JOB **PROPOSED RESIDENCE**

LOCATION **24 PADDOCK CLOSE
ELERMORE VALE**

DWG No.
6269-CP3

UPPER FLOOR PLAN
SCALE 1:100

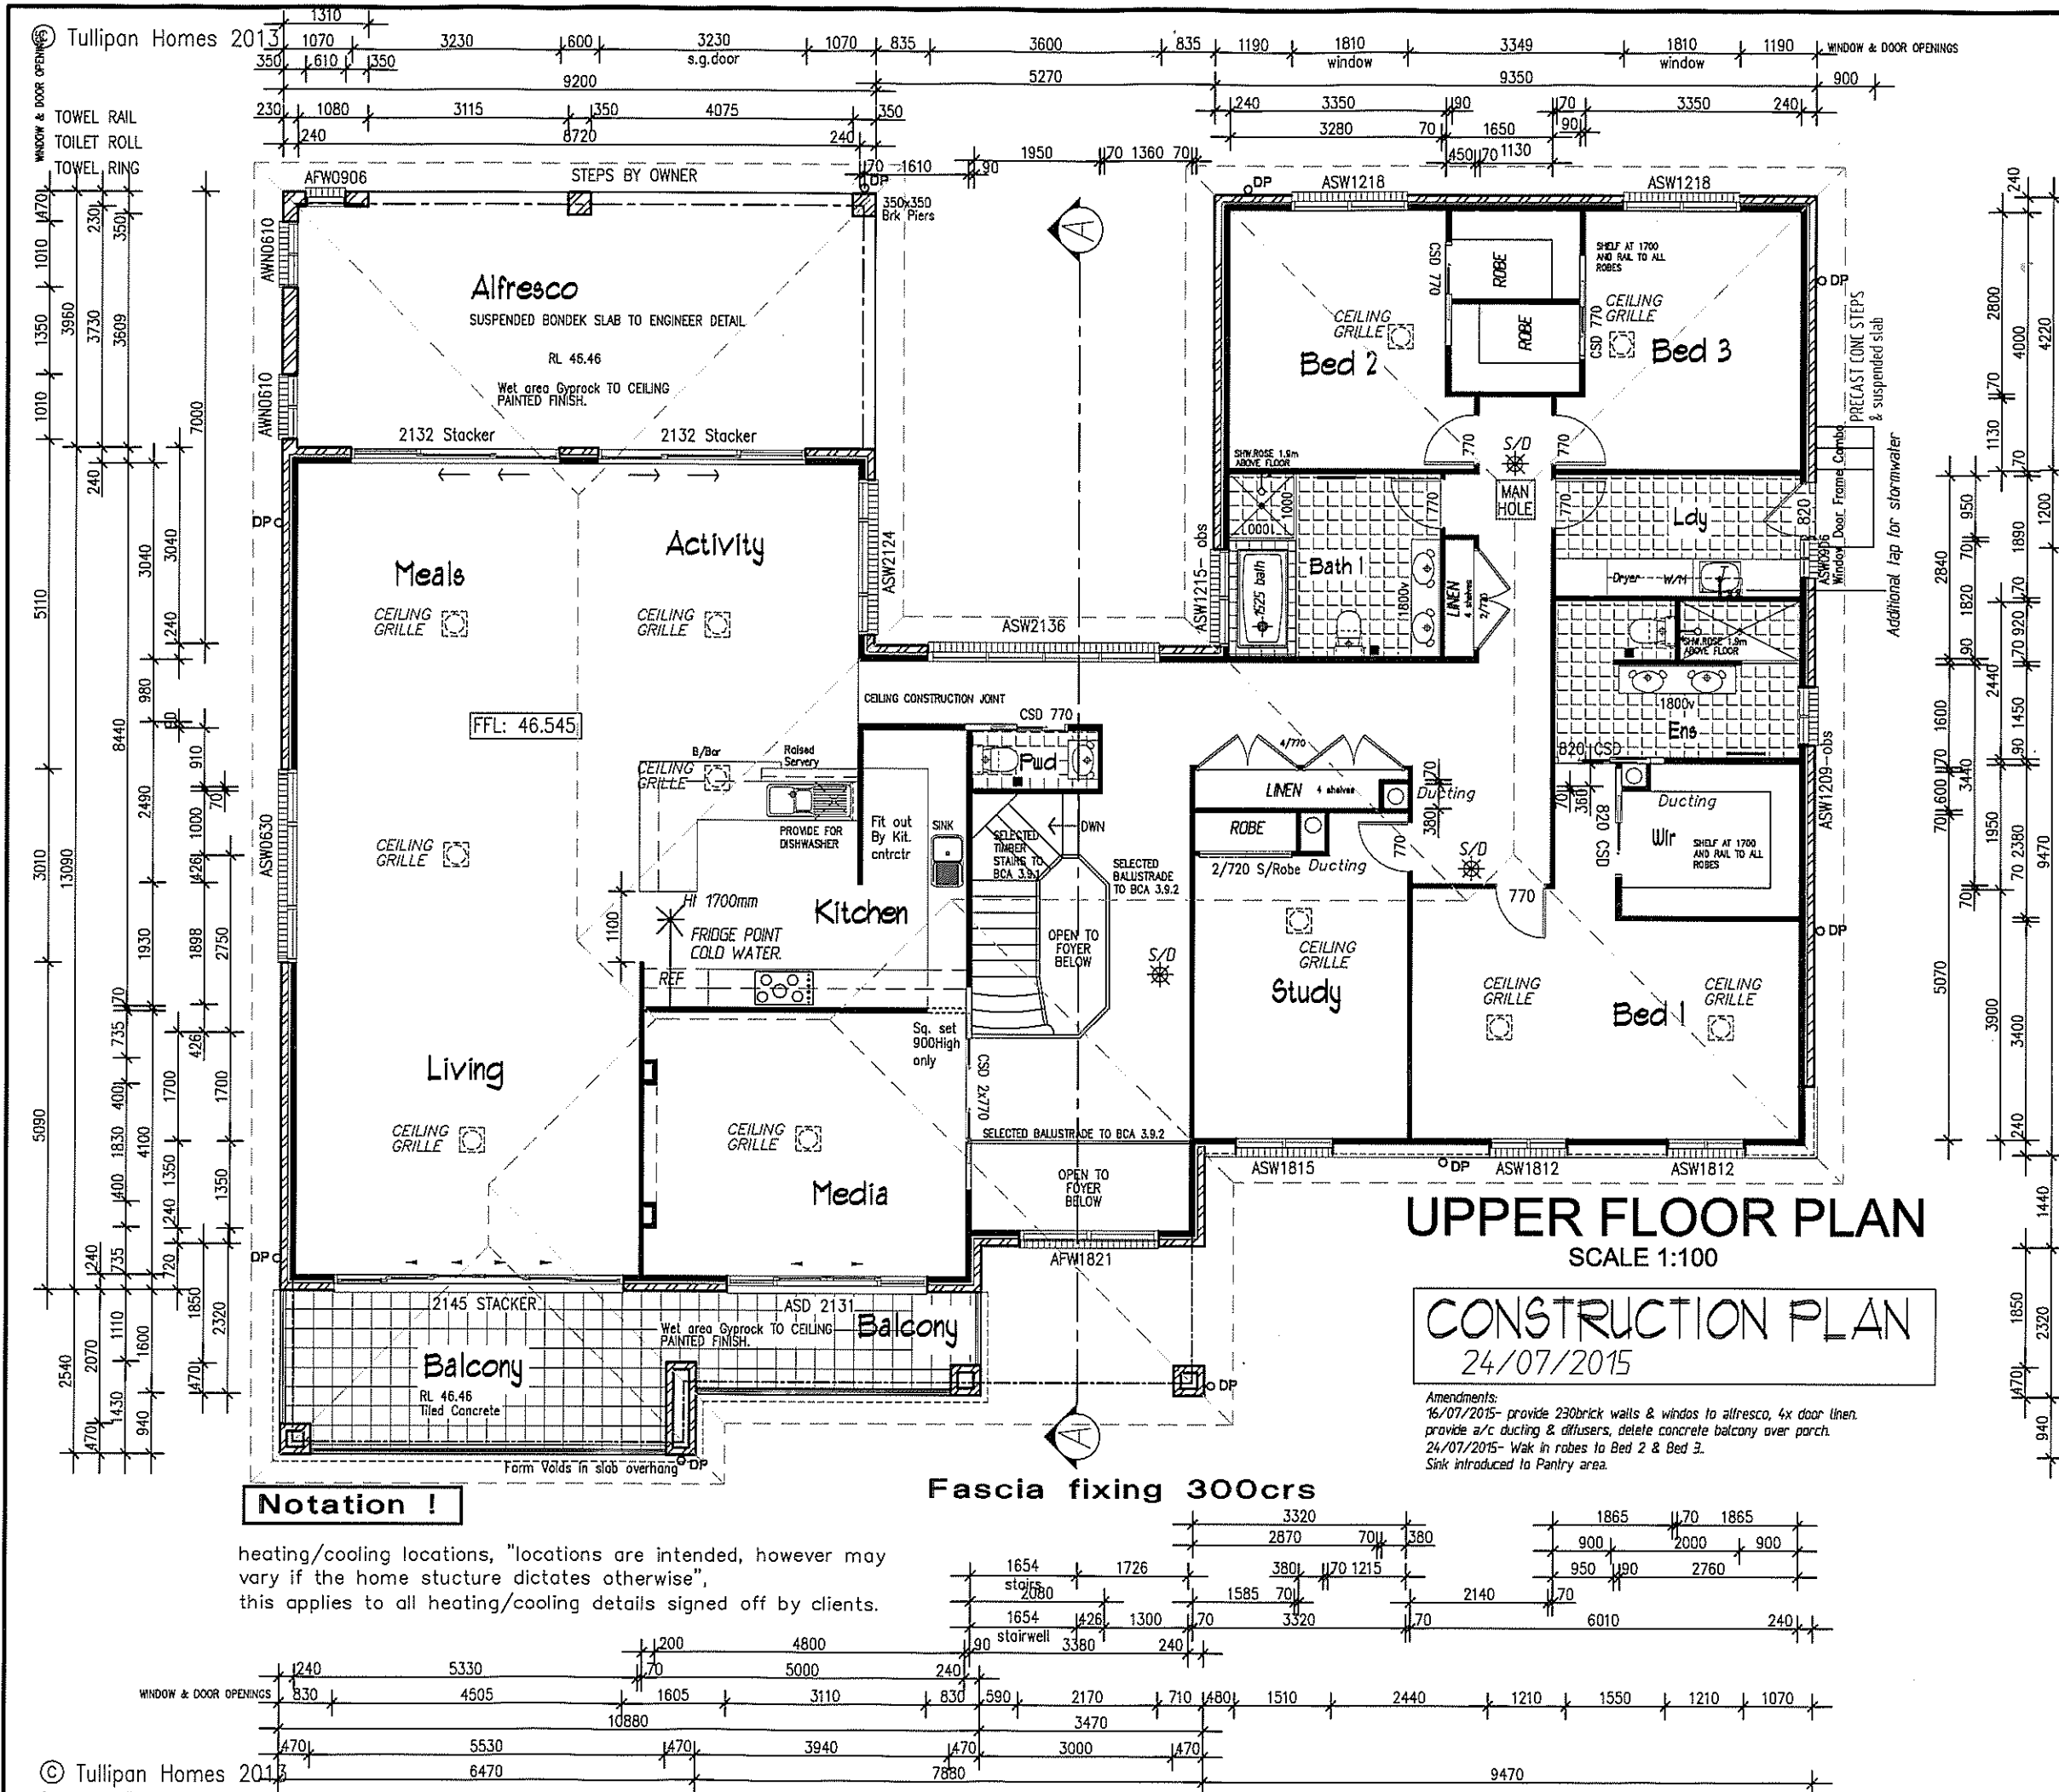
Amendments:
16/07/2015- provide 230brick walls & windows to alfresco, 4x door linen.
provide a/c ducting & diffusers, delete concrete balcony over porch.
24/07/2015- Wok in robes to Bed 2 & Bed 3.
Sink introduced to Pantry area.
